Access Compliance Report

Public Rights-of-Way

Intersection ID: 24499	Main Street: BECKMORE_PL	Cross Street: SAINTFIELD_PL	Location: NE
ADA ID: 8D31171EFDA8	Ramp Type: Perp	Initial Pass/Fail: Fail	Overall Compliance: No
Severity Score: 13.75			
Codes/Mitigation Info/Possible Solution		Field Measurements/Component Compliance

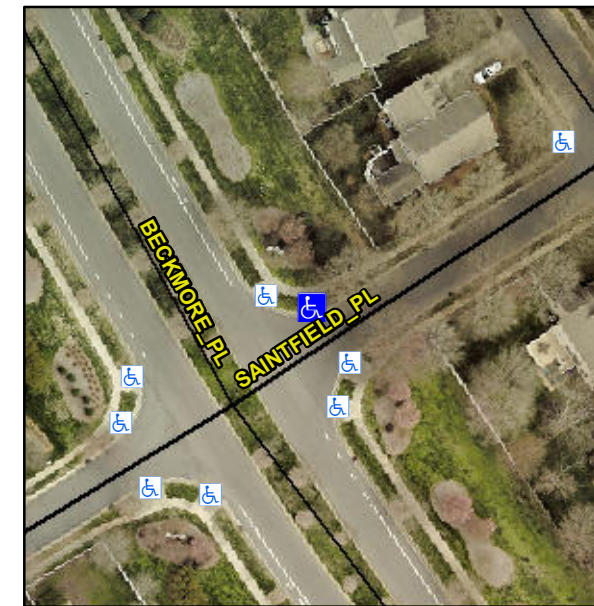
Not Found, R304.2.2, R304.5.3

Compliance	Description	Data	Compliance	Description	Data
N/A	Ramp Length (in)	98.0	No	Ramp Slope (%)	9.8
Yes	Ramp Width (in)	66.0	No	Ramp XSlope (%)	2.4
N/A	Flare Type LT	N/A	N/A	Flare Type RT	N/A
N/A	Flare Slope LT (%)	N/A	N/A	Flare Slope RT (%)	N/A
N/A	Flare Traversable LT?	N/A	N/A	Flare Traversable RT?	N/A
N/A	Landing Length (in)	N/A	N/A	DWS Provided?	N/A
N/A	Landing Width (in)	N/A	N/A	DWS Contrast?	N/A
N/A	Landing Slope (%)	N/A	N/A	DWS Length (in)	N/A
N/A	Landing X Slope (%)	N/A	N/A	DWS Full Width?	N/A
N/A	Landing Curb? (Y/N)	N/A	N/A	DWS Offset (in)	N/A
N/A	Shared Landing?	N/A			
N/A	Gutter Ponding?	N/A	N/A	Gutter Slope (%)	N/A
N/A	Gutter Lip Ht (in)	N/A	N/A	Gutter X Slope (%)	N/A
N/A	Painted X Walk1?	No	N/A	Painted X Walk2?	N/A
	X Walk 1 Direction	To S		X Walk 2 Direction	N/A
N/A	X Walk 1 Width (in)	N/A	N/A	X Walk 2 Width (in)	N/A
	X Walk 1 Slope (%)	6.0		X Walk 2 Slope (%)	N/A
	X Walk 1 X Slope (%)	2.7		X Walk 2 X Slope (%)	N/A

Remove & Replace Entire Ramp.
